**ITEMS RECEIVED AFTER THE PRODUCTION OF THE REPORT  
FOR THE PLANNING COMMITTEE  
TO BE HELD ON 26 APRIL, 2018**

# MATTERS ARISING FOR COMMITTEE

COMMITTEE DATE : 26 April 2018

**Planning Layout, reference 1605PH2/GA/90/03 Rev A**

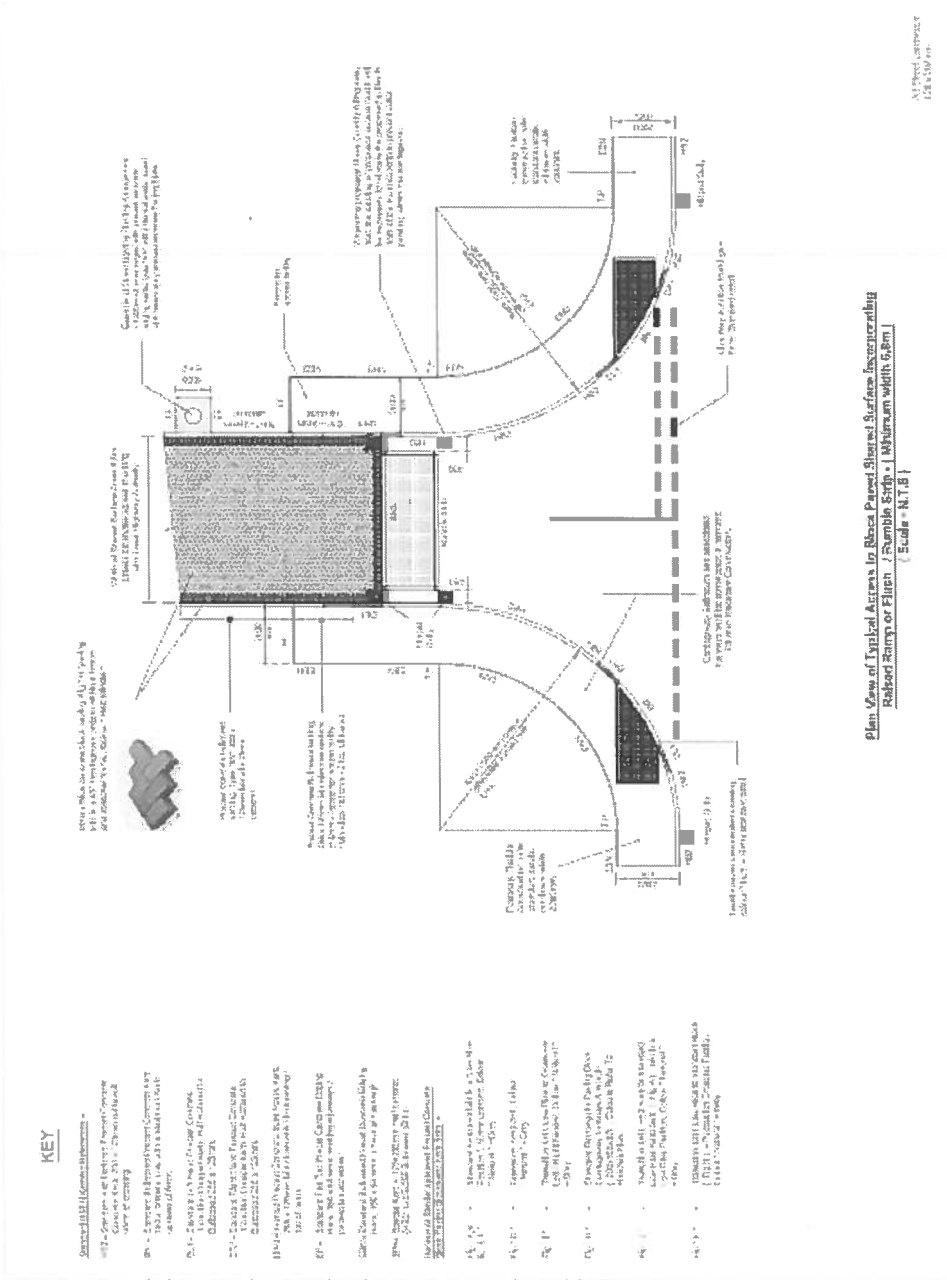
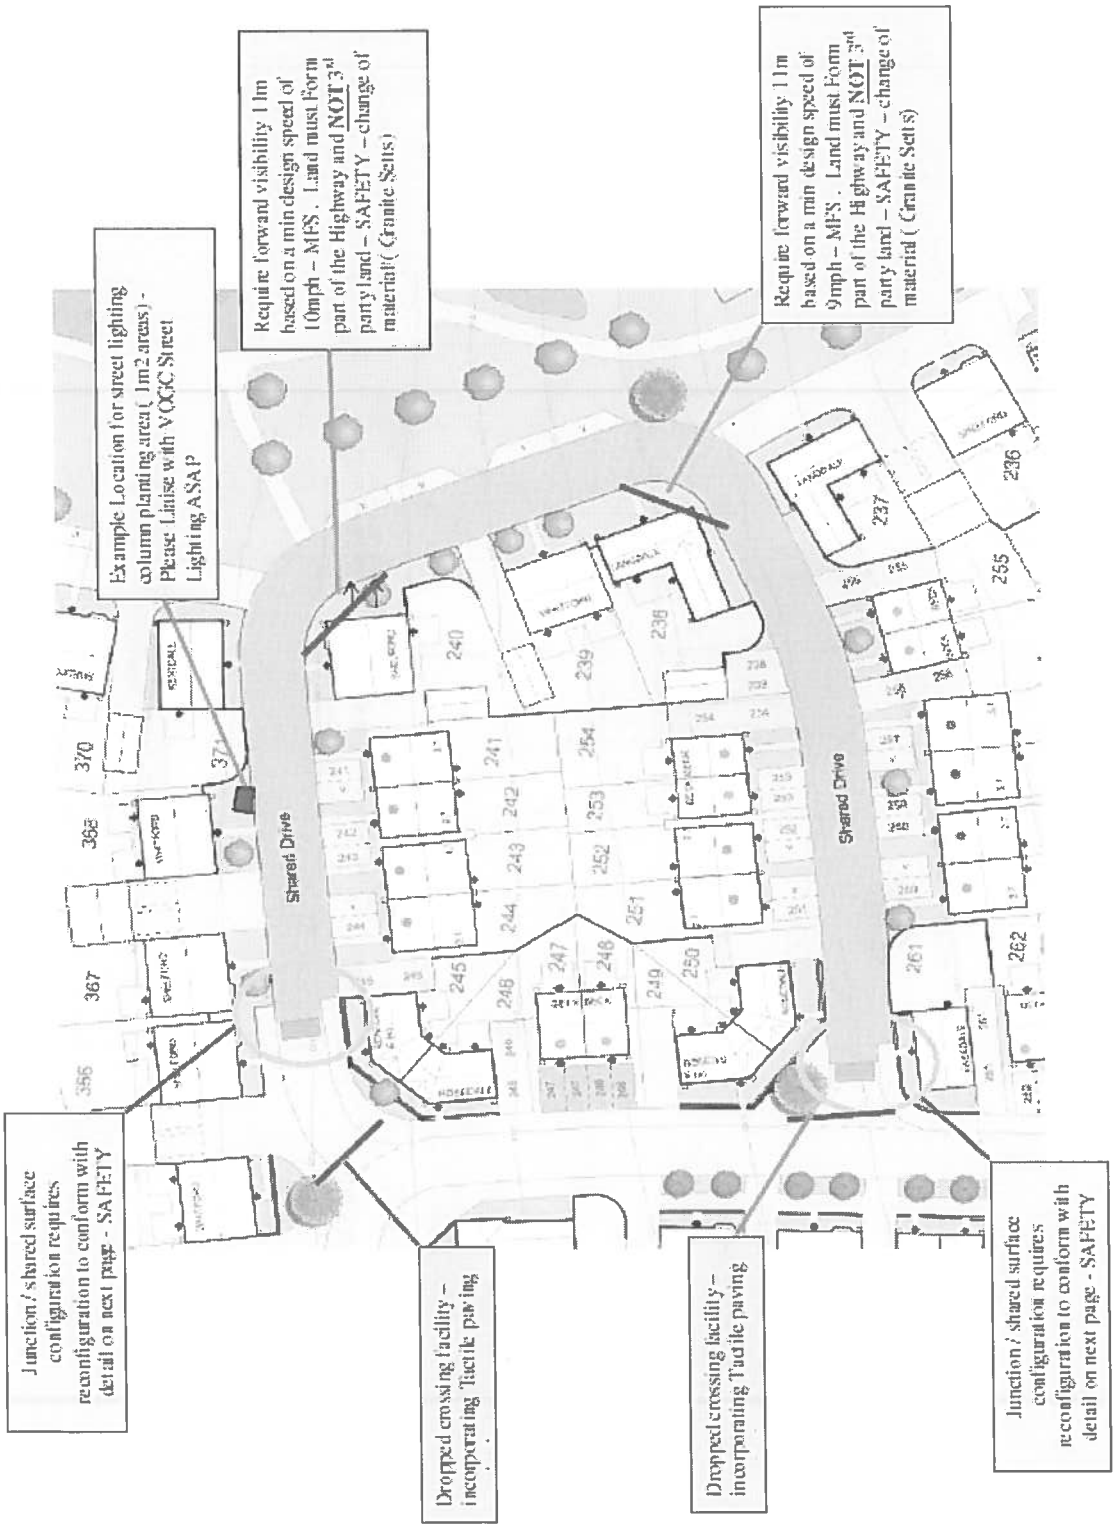
Safety Issues - Stagger in footway can result in issues for visual impaired - Please realign footway both sides of road

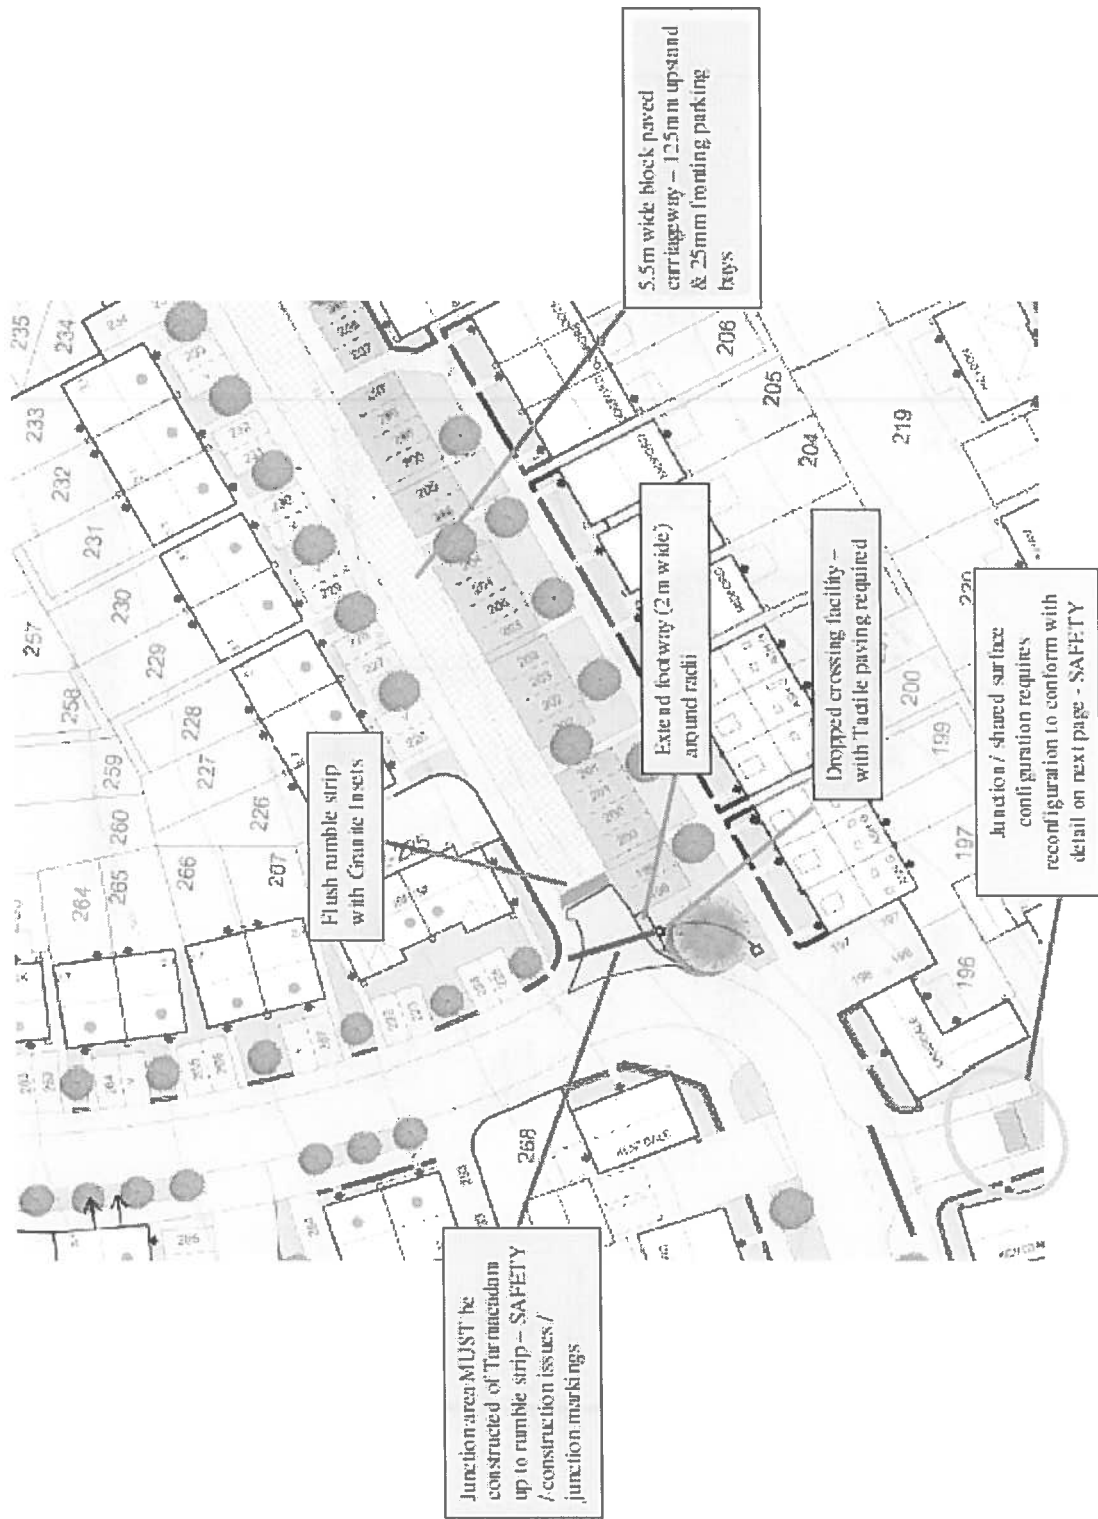
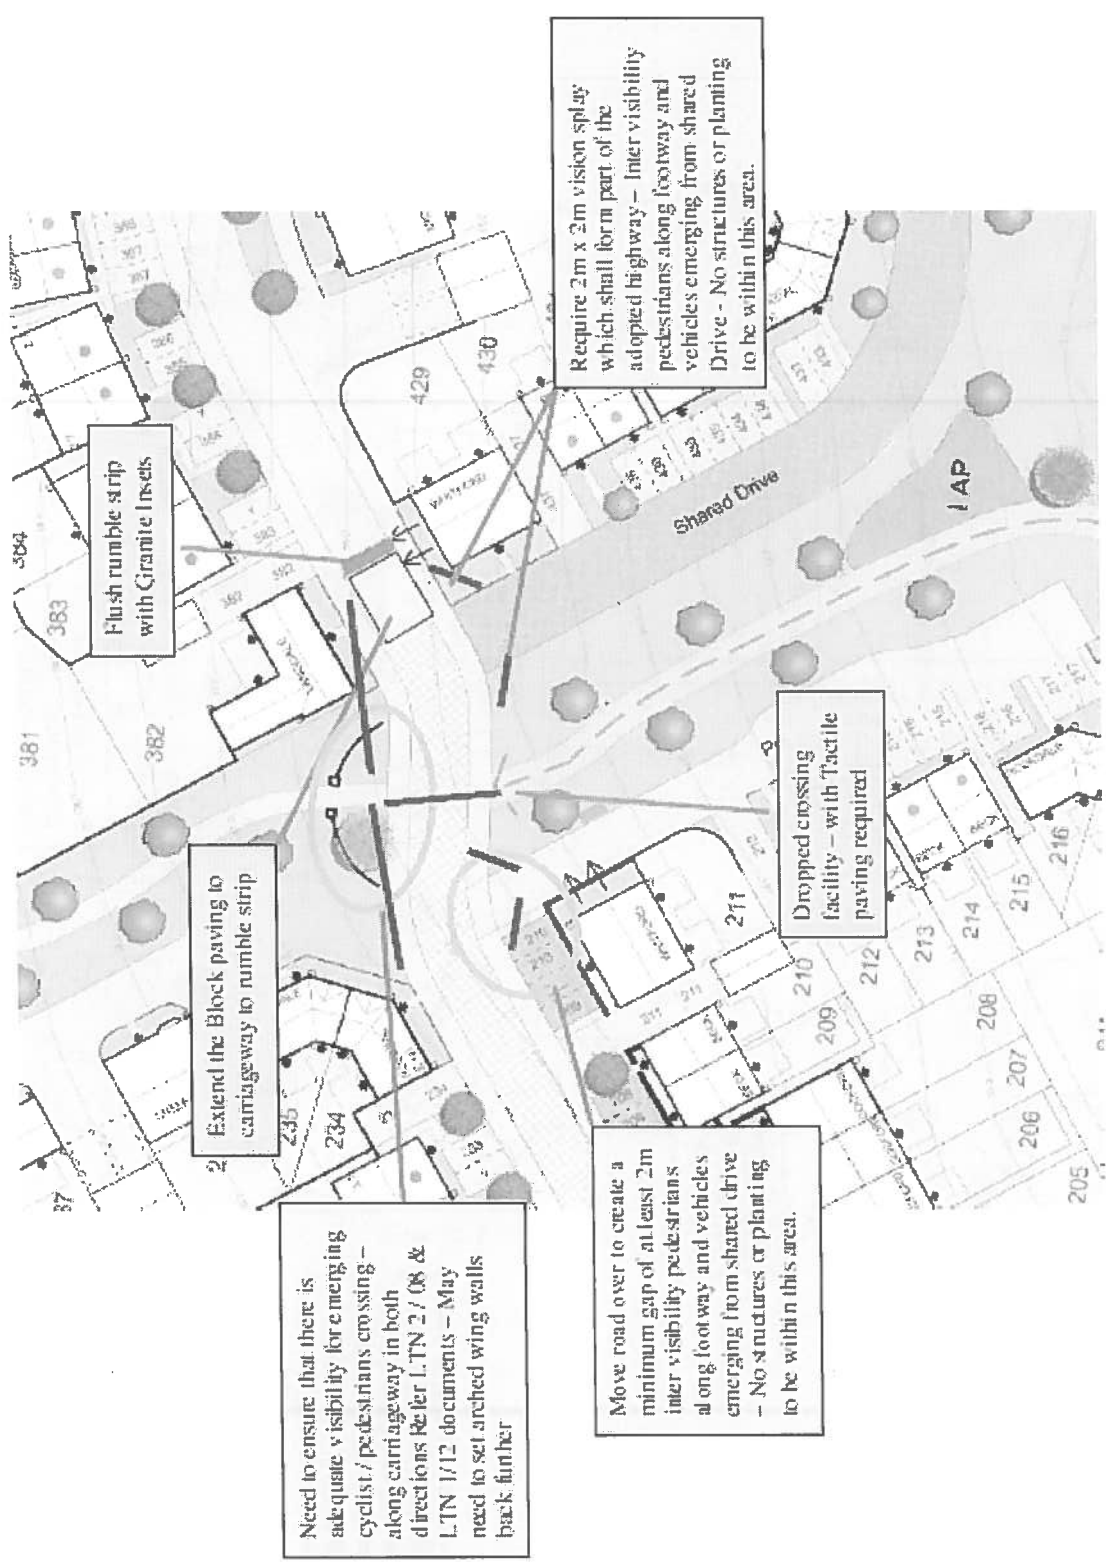
Safety issues - Stagger in footway can result in issues for visual impaired - Please realign footway both sides of road and re-arrange verges

Flush rumble strip with Granite Insets

Extend the Block paving to carriageway to rumble strip

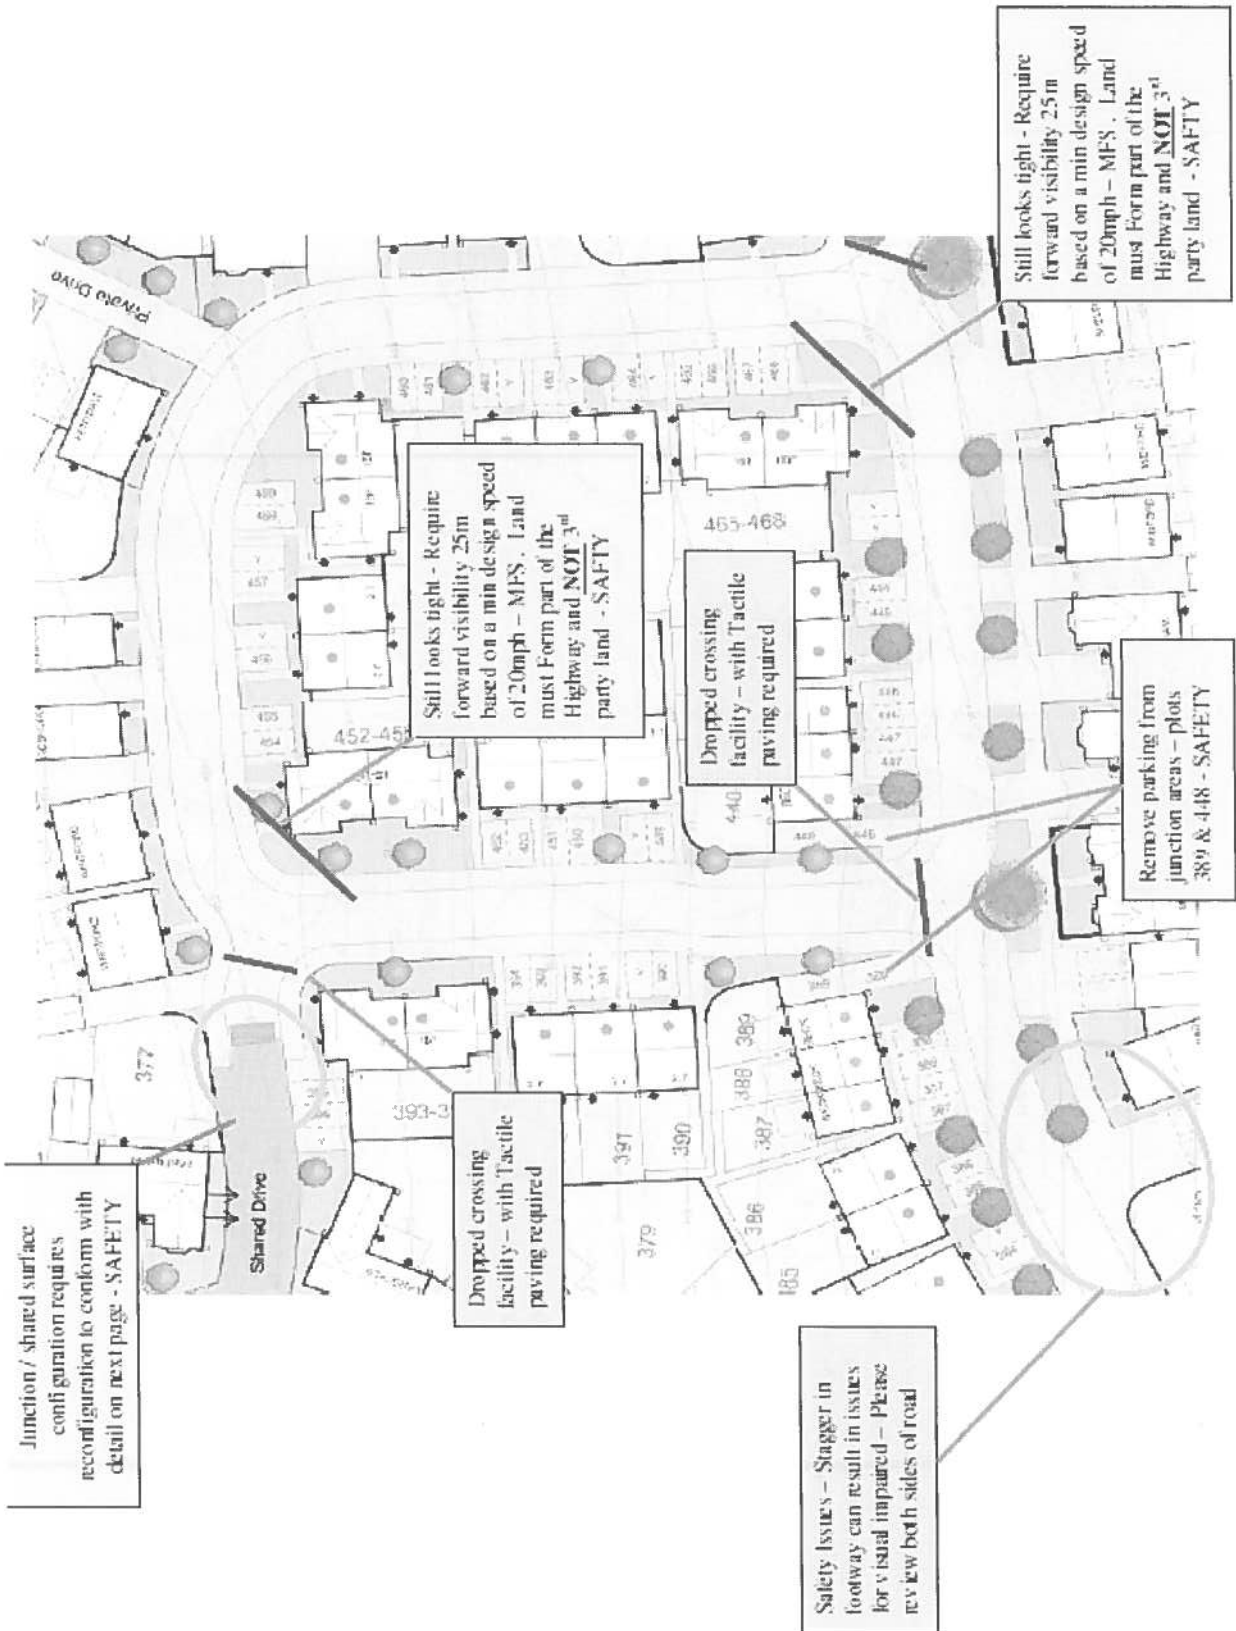
Need to ensure that there is adequate visibility for emerging cyclist / pedestrians crossing along carriageway in both directions Refer LTN 2 / 08 & LTN 1/12 documents – May need to set arched wing walls back further

Require 2m x 2m vision splay which shall form part of the adopted highway – Inter visibility pedestrians along footway and vehicles emerging from shared Drive - No structures or planting to be within this area.

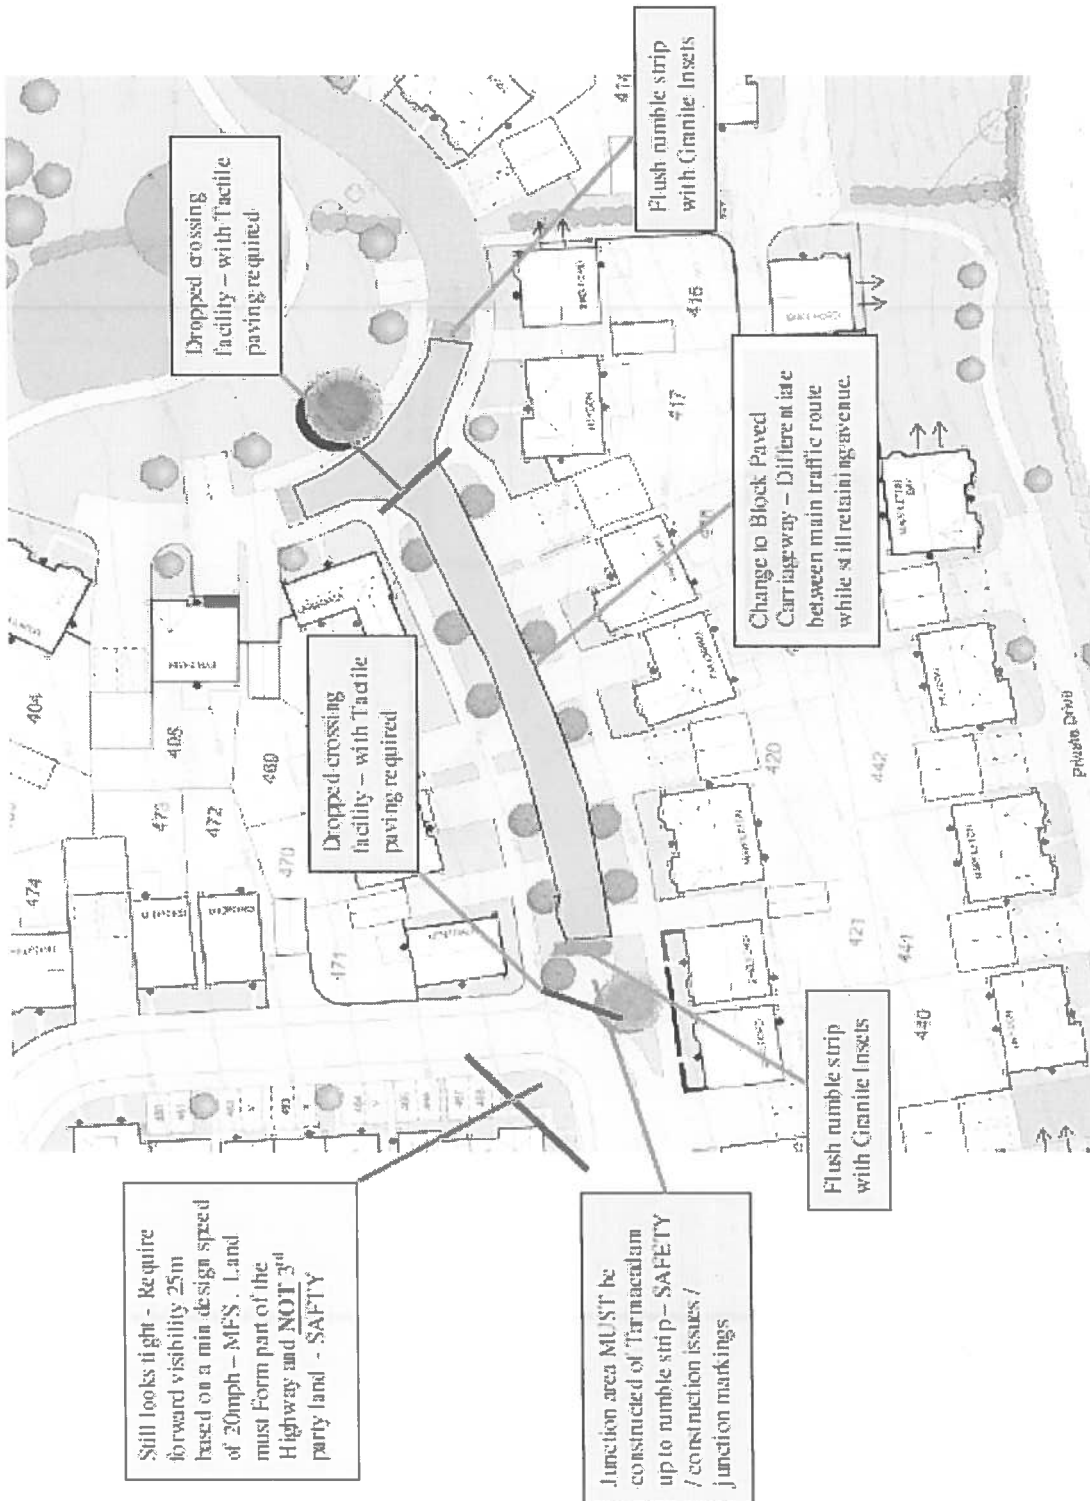
Dropped crossing facility – with Tactile paving required

Move road over to create a minimum gap of at least 2m inter visibility pedestrians along footway and vehicles emerging from shared drive – No structures or planting to be within this area.
